**N8975A-02**

# S E R V I C E N O T E

## N8975A NFA Series Noise Figure Analyzer

**Connector A3J10 does not have suitable locking mechanism**

Fig 1 - A3 Assembly Showing Location of Connector J10

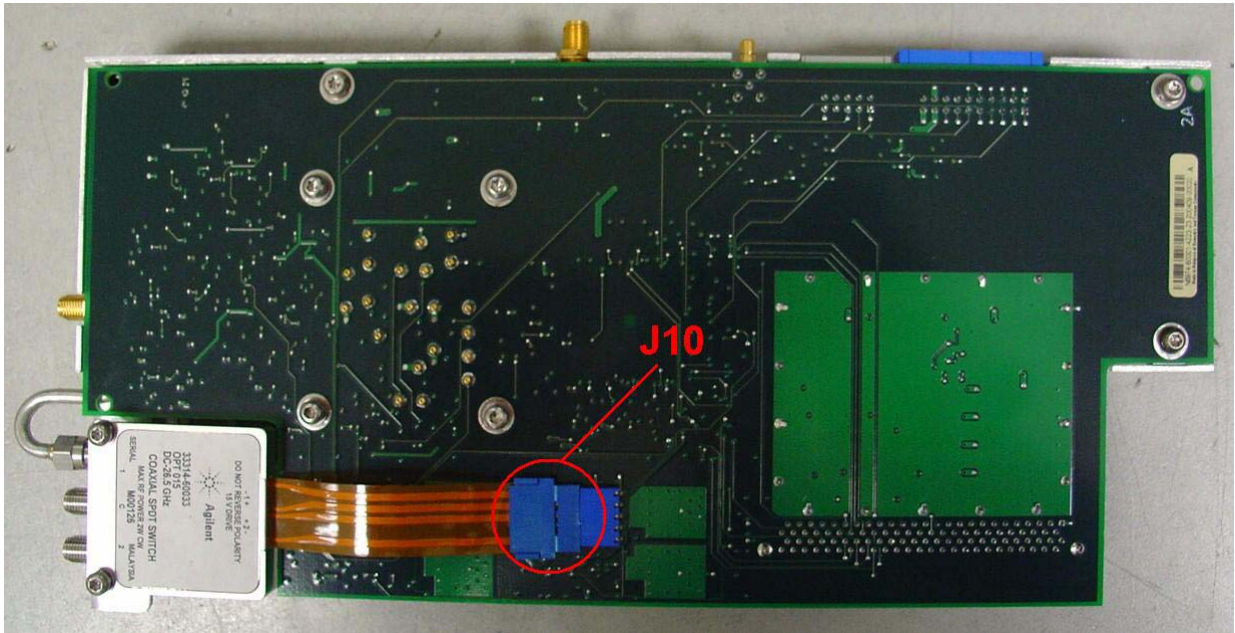
Connector J10 on the A3 Microwave Front End Assembly (N8974-61001) does not have a suitable locking mechanism. An investigation has shown that it is possible during transit, or other forms of vibration, that this connector can work loose then make and break intermittently, causing Alignment and self test errors. This connector controls the microwave switch that routes the input signal to the A3 Microwave Front End Assembly (for frequencies above 3 GHz), or the A2 RF Front End Assembly (10MHz – 3 GHz)..

Add RTV, or some other form of suitable adhesive, across the join in the connector to hold it in place.
